MANDATORY SERVICE BULLETIN

NUMBER: SB-011

SUBJECT: FLIGHT SURFACES; ADJUSTMENT

KODIAK 100 Series Aircraft, Serial Numbers 100-0001 through 100-0003

Figure 1: Rudder Trimming

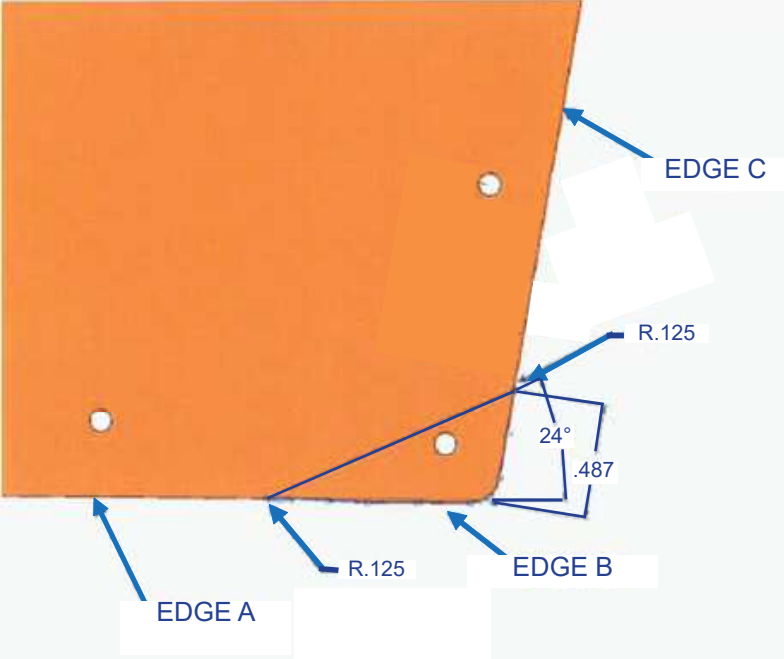
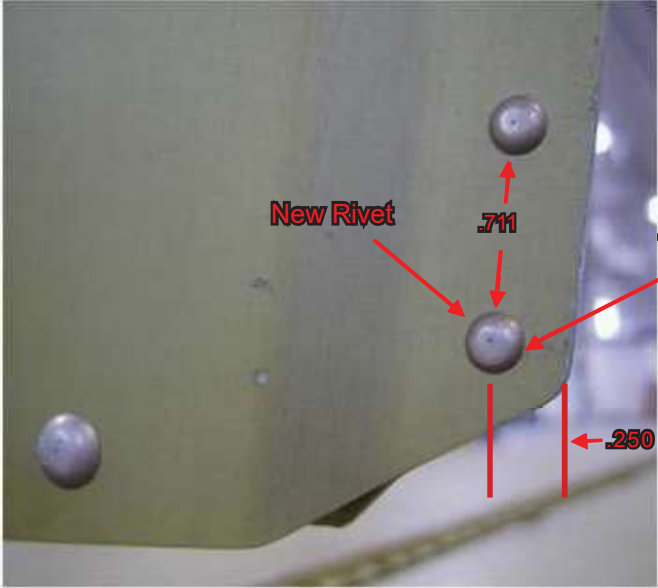
This Service Bulletin contains instructions to increase the clearance between the rudder and elevator flight control surfaces.

Task	Instruction
1	Removal of the rudder is not necessary in order to accomplish this task. Some type of protection for the elevator may be used if so desired.
2	<p>Trim rudder according to the dimensions given. .487" dimension is measured upward from the virtual sharp of "EDGE B" and "EDGE C". 24° dimension measured from "EDGE A". Add R.125" corner rounds.</p> 
3	<p>Drill the new tooling hole .711" below the existing rivet. The new hole should be .098" diameter. Use a MS20470AD-3 rivet.</p> 
4	Alodine, Prime and Paint the bare areas to prevent corrosion.

Task	Instruction	
5	Re-balancing of the rudder is not required. The small amount of weight that was removed is negligible.	
6	Annotate the work performed in the Kodiak 100 Log Books .
